I am writing to voice my objection of the proposed development 2020/0785/RG3

Objection to the position of Block 14 on the plan 2020/0785/RG3

Erection of 36no. dwelling houses and 6no. apartments facilitated by the demolition of 89-93 Rookery Lane. Associated external works including parking, access roads and landscaping (Revised Plans)

Plan view with overlaid Property outlines.
(Ground Maps, building positions & sizes to scale,
as true as possible within map measurement limits)

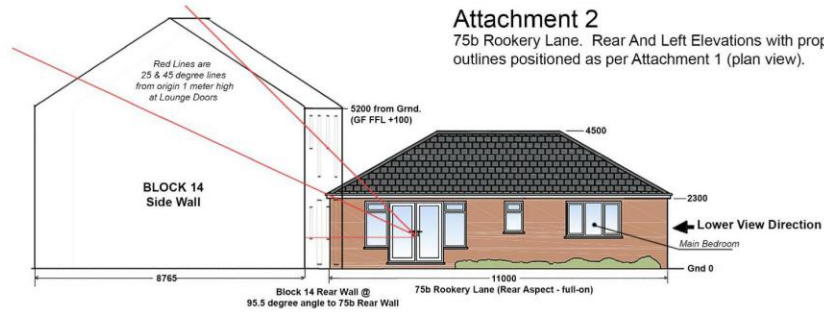
Finally, to give absolute clarity, this objection relates only to Block 14 and its position on the planning map (Reference 1). In all reasonableness, logic dictates that a bungalow in place of Block 14 would have a minimal impact on our property and lifestyle. It would also negate, at a stroke, all of our concerns raised within this document. Should this prove not feasible however, then we urge the Planning Council to amend the current plan in any other way that may reduce or negate the impact that Block 14 will have on number 75b, Rookery Lane.

Plan view of *Bungalows #75* overlaid on the S.E. corner of Proposed Site Plan (Reference 1). Whilst not a CAD drawing, it was assembled to scale in a computer graphics program, by matching the outlines of surrounding plots on Rookery Lane & Hainton Road. small measurement errors are due to map resolution. (*Apologies if breaking any copyright, intended only for the Planning Committees' convenience*).

75b Rookery Lane. Rear And Left Elevations with proposed Block 14 outlines positioned as per Attachment 1 (plan view).

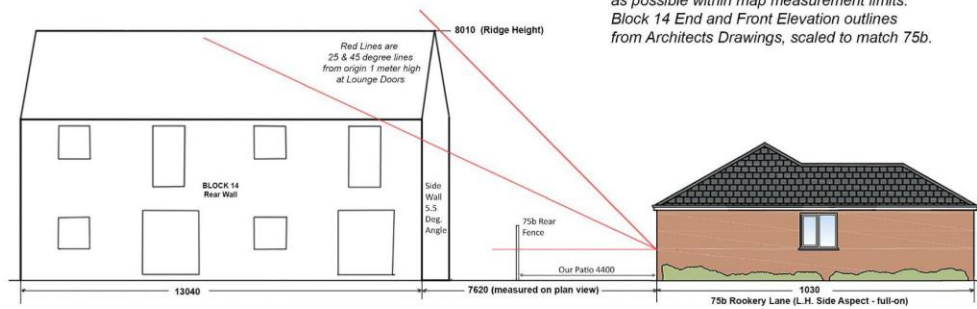
Note: I have zero expertise in architecture. However, I have marked the 25 and 45 degree lines on the attachments, these may be of use to the Planning Committee, or not? They were done for my guidance and understanding, following research indicating that it is a common requirement in many UK council planning strategies (Lincoln unknown): e.g. "The 45-degree rule is a common guideline used by local planning authorities to determine the impact from a housing development proposal on sunlight and daylight to the neighbouring properties".

The current peace and tranquillity of the *Bungalows #75* retired community, and 75b in particular, has endured throughout their 4 year existence. Why then, would it would seem reasonable to place the patio of a younger family home just 4.4 meters from the patio doors of the main living area of a bungalow? With a combined life experience of 150 years, we do not find it hard to envisage our summers disrupted by boisterous children playing on their own patio: imagine trampolines, or balls flying over the fence, whilst we relax by open patio doors? Yes, it is planned to be that close! and worse, immediately opposite our (lounge) patio doors!
